**CITY OF FORT COLLINS
TYPE 1 ADMINISTRATIVE HEARING**

FINDINGS AND DECISION

PROJECT NAME: The Ellie at Old Town North

CASE NUMBER: PDP # 240002

The landscape plan image below shows the layout of access and buildings:

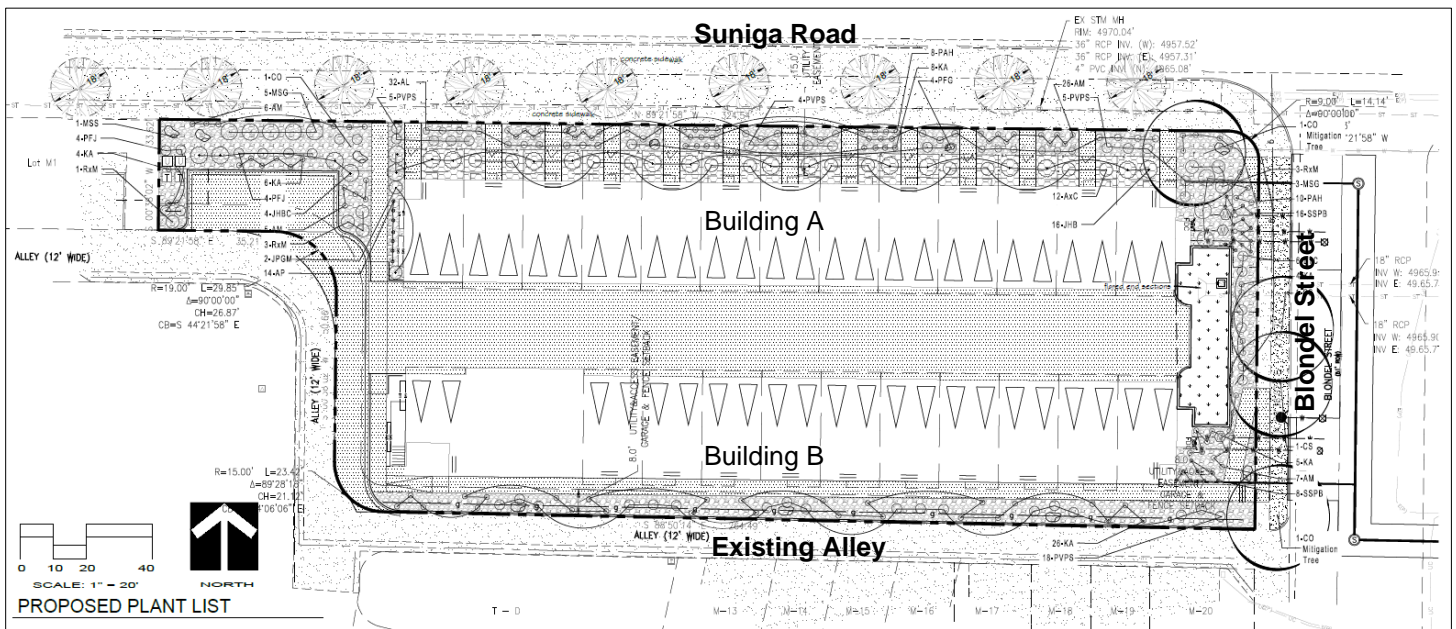
- Individual units have ground floor entrances, balconies, and rooftop decks, with exceptions for one stacked pair of units at the west end of Building B (no rooftop for the downstairs unit; no ground floor entrance for the upstairs unit).
- Parking is provided in 2-car garages and one van-accessible 1-car garage along with 5 outdoor spaces. In addition to parking in the plan, Blondel Street frontage allows for up to 3 parking spaces.
- Vehicle access is from two existing alleys, one extending from Osiander Street one-half block to the south; and one extending west from Blondel Street along the southern edge of the property.
- A Modification of a Standard is included for the lack of any trees along the front (south) side of Building B.

Staff was surprised to see a plan with a second building facing the alley, as opposed to a building(s) facing Suniga with parking or garages along the alley, similar to the typical orientation of dwellings along alleys, including other dwellings along this alley. Staff and applicants discussed the compatibility of this arrangement with the neighborhood context, and staff considered the constrained quality of the alley frontage as a pedestrian environment along the front of Building B.

Staff finds that only one Land Use Code standard raises a question of non-compliance in this development program—that is a landscaping standard for trees around buildings which can not be met on the south side of Building B because of an existing gas line along the alley. A Modification of Standards request for that standard is included.
